Landscape Review Committee
Community Development Center, 231 NE 5th Street
October 16, 2019
12:00 PM

DATE: October 16, 2019
TO: Landscape Review Committee Members
FROM: Jamie Fleckenstein, Associate Planner
SUBJECT: Landscape Plan Review Application (L 20-19)

**DECISION, CONDITIONS, FINDINGS OF FACT AND CONCLUSIONARY FINDINGS FOR THE
APPROVAL OF A LANDSCAPE PLAN AT 2370-2410 NE HIGHWAY 99W/R4415BB01003**

DOCKET: L 20-19 (Landscape Plan Review)

Figure 2: Proposed Landscape Plan (Enlargement)

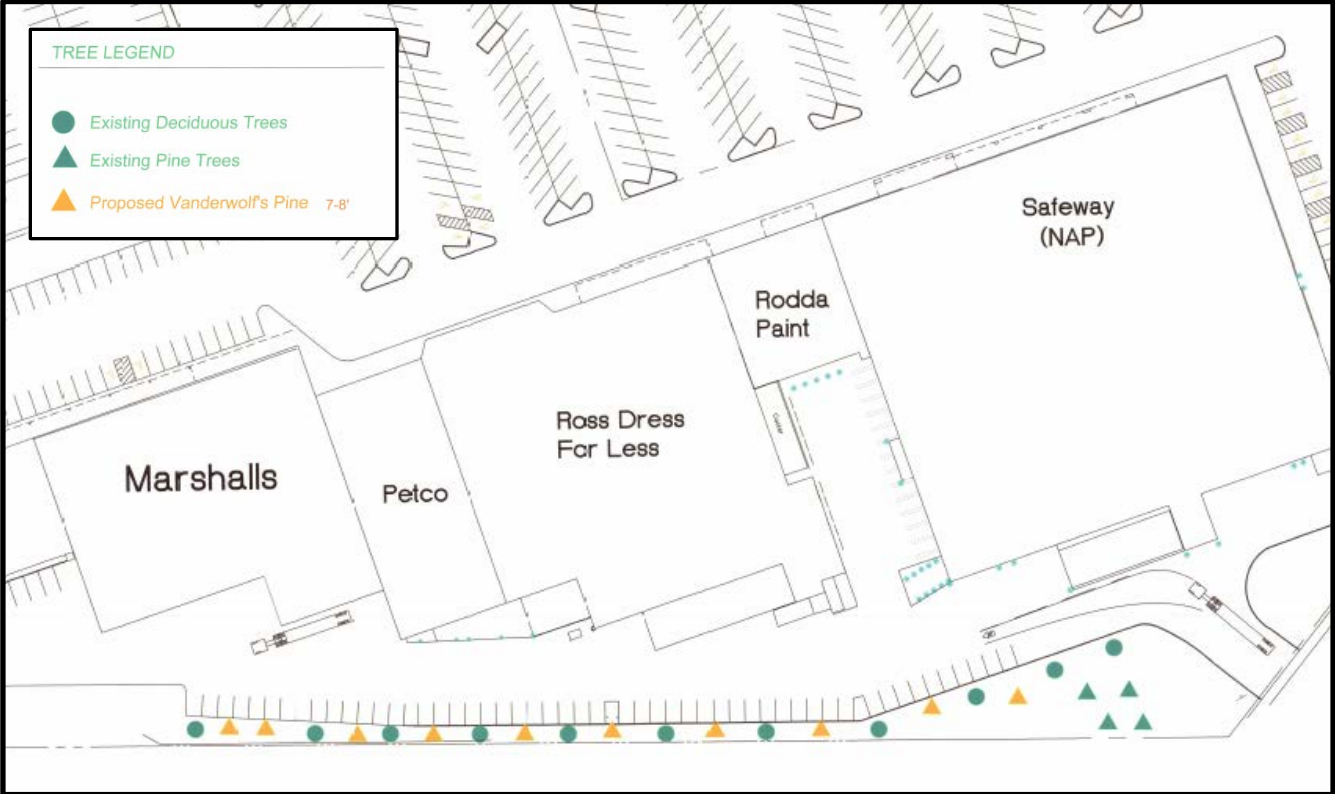
Call for locates. Avoid planting new trees directly overtop existing buried primary power. Keep a minimum three foot clearance between mature tree canopy and existing three phase power transformer towards the west end of the proposed tree plantings. This may mean eliminating a proposed tree.

1. That the applicant shall install landscaping as shown on the landscape plan dated August 20, 2019.
2. That the applicant contact the appropriate utility-locate service (dial 811 or 800-332-2344) prior to planting to ensure that underground utilities are not damaged during this process. If any facilities are damaged during planting, contact McMinnville Water & Light immediately at 503-472-6158.

3. That the applicant shall maintain proper clearances around any water and electrical services located on the site. Landscaping shall not be placed within four (4) feet of fire hydrants, within four (4) feet of water valves, within four (4) feet of vaults, within three (3) feet of the back or side of a transformer, or within one (1) foot of water meters. A three (3) foot minimum clearance shall be maintained between mature tree canopy and the existing three phase power transformer at the west end of the proposed tree planting area. Minor adjustments in plant placement from the locations shown on the approved landscape plan are allowed if relocation is necessary to meet minimum clearances.

Lots 9 and 11:

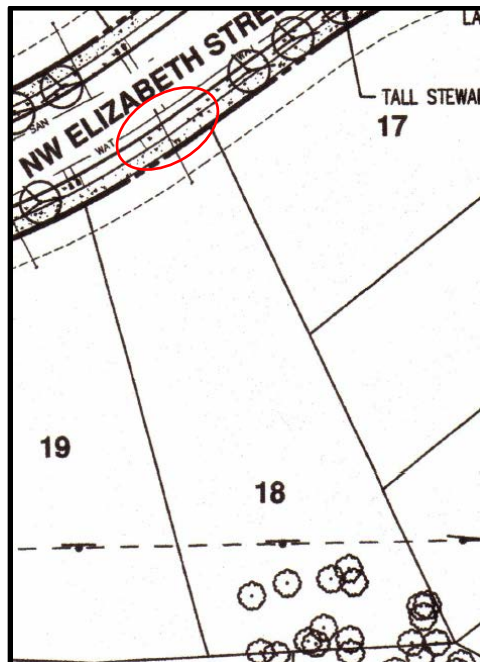
In front of lots 9 and 11, the sidewalk changes to a curb-tight sidewalk to accommodate the passage of the drainage channel under the roadway. As a result, there is no curb-side planter strip in front of Lot 9 where a street tree could be planted, and the area in front of Lot 11 where the sidewalk is not curb-tight is dedicated to driveway access to the lot. Therefore, no street trees are required adjacent to Lots 9 and 11.

Lot 20:

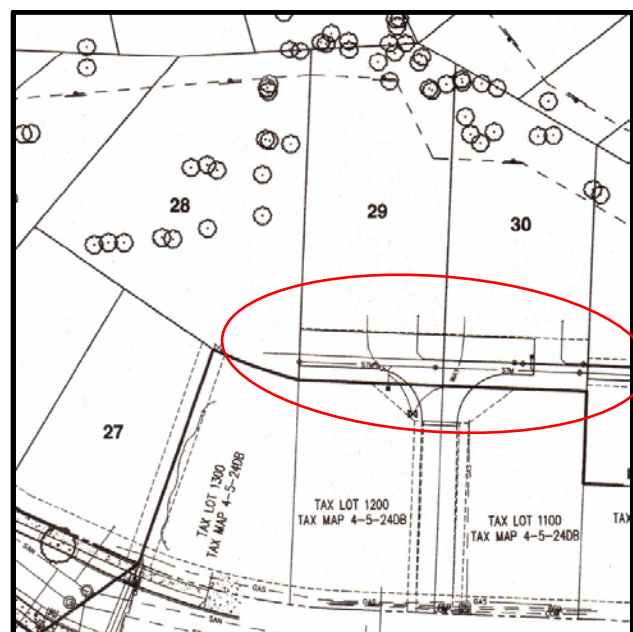
There is approximately 16 feet from the sanitary sewer lateral serving Lot 20 and the eastern edge of the driveway. After applying the 10 foot spacing standard to sewer lines and the (five) 5 foot spacing standard from private driveways, there is room for one (1) additional street tree to be planted. Therefore, a condition of approval is included to require a street tree in this location.

Lots 28, 29, and 30:

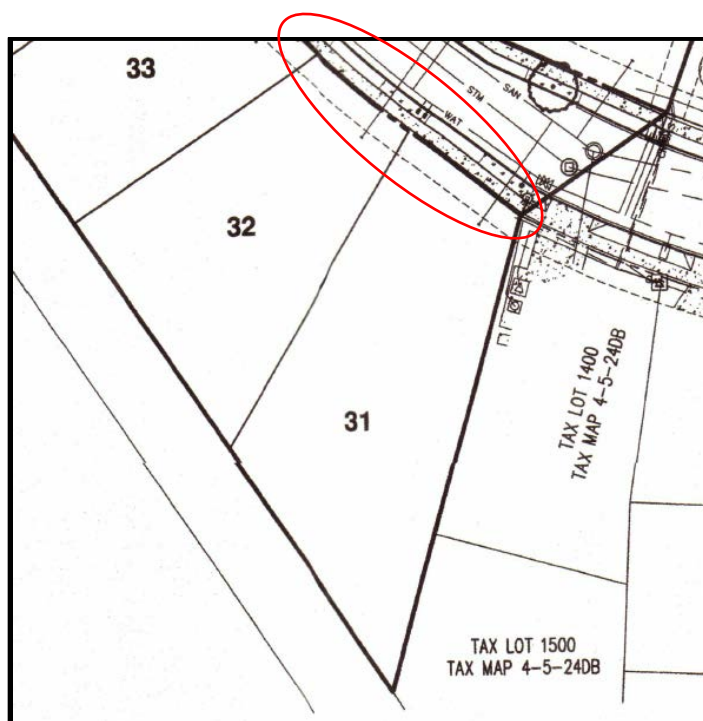
Lots 28, 29, and 30 are accessed via an access easement and do not have any right-of-way frontage. Therefore, street trees are not required adjacent to these lots.

Lots 31 and 32:

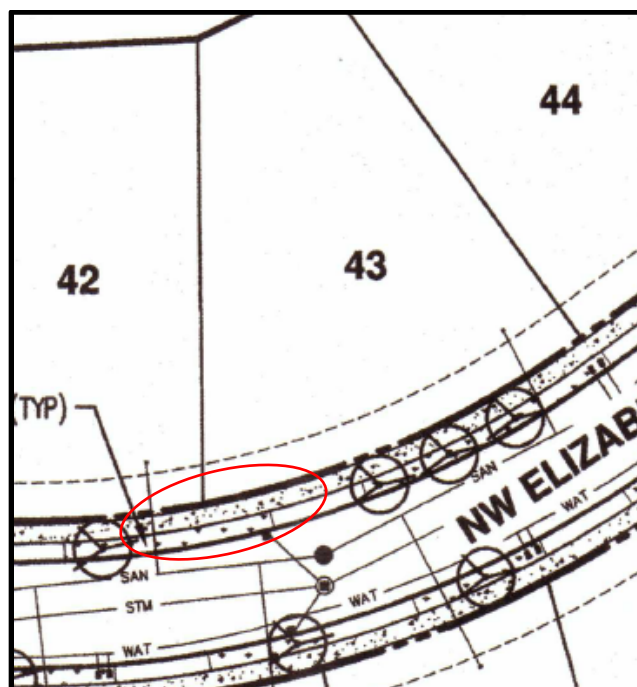
There is insufficient space in the planter strip adjacent to Lot 31 between the sanitary sewer lateral serving the property and the driveway to accommodate a street tree. Likewise, there is insufficient space in the planter strip adjacent to Lot 32 between the sanitary sewer lateral serving the property, the driveway, and the water meters to accommodate a street tree. Therefore, street trees are not required adjacent to these lots.

Lots 9 and 11:

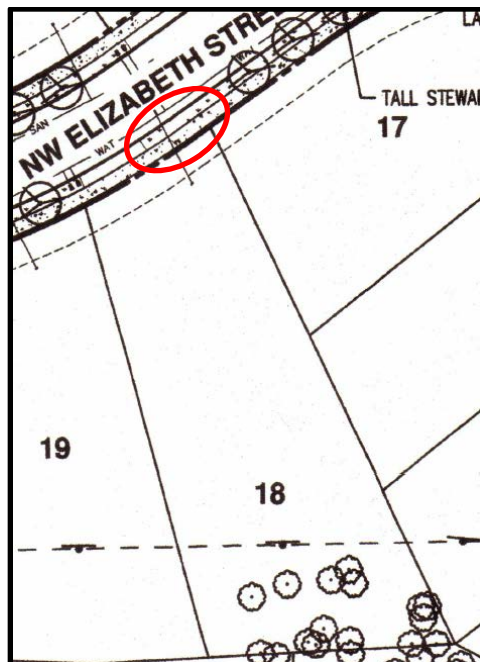
In front of lots 9 and 11, the sidewalk changes to a curb-tight sidewalk to accommodate the passage of the drainage channel under the roadway. As a result, there is no curb-side planter strip in front of Lot 9 where a street tree could be planted, and the area in front of Lot 11 where the sidewalk is not curb-tight is dedicated to driveway access to the lot. Therefore, no street trees are required adjacent to Lots 9 and 11.

Lots 28, 29, and 30:

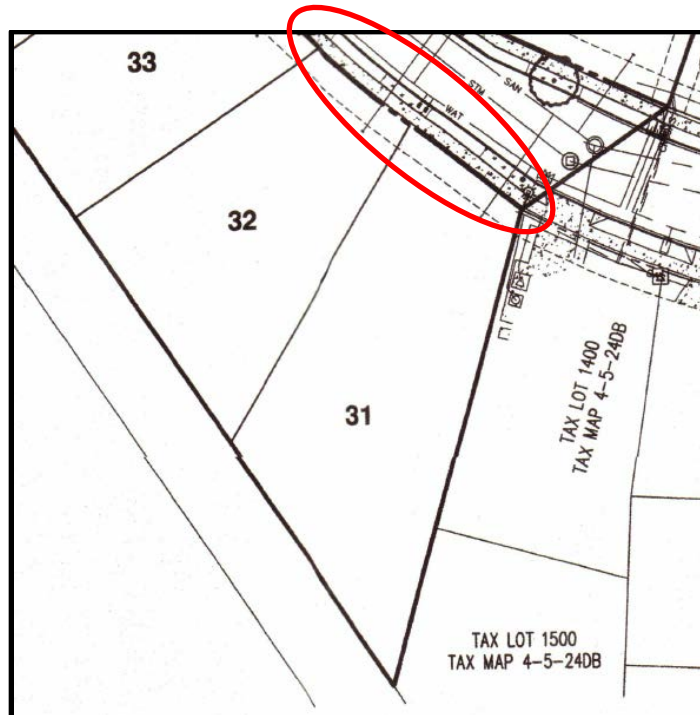
Lots 28, 29, and 30 are accessed via an access easement and do not have any right-of-way frontage. Therefore, street trees are not required adjacent to these lots.

Lots 31 and 32:

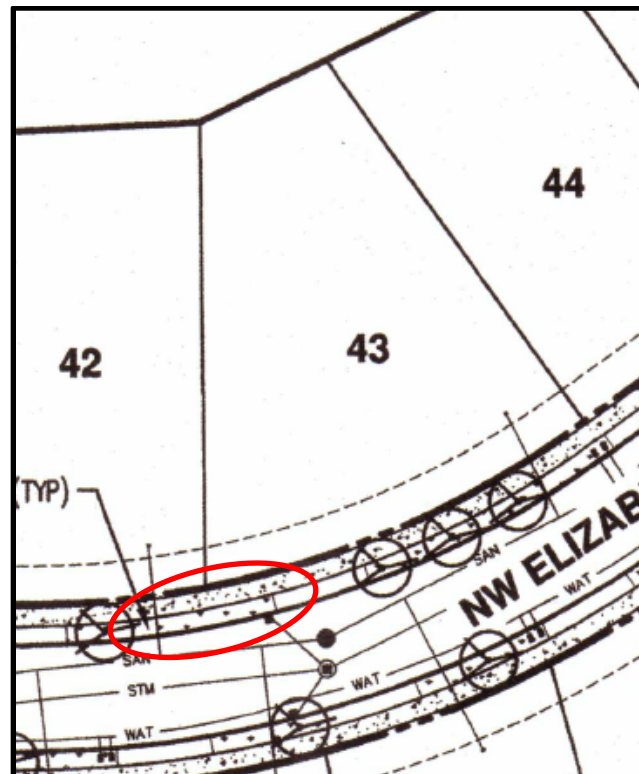
There is insufficient space in the planter strip adjacent to Lot 31 between the sanitary sewer lateral serving the property and the driveway to accommodate a street tree. Likewise, there is insufficient space in the planter strip adjacent to Lot 32 between the sanitary sewer lateral serving the property, the driveway, and the water meters to accommodate a street tree. Therefore, street trees are not required adjacent to these lots.
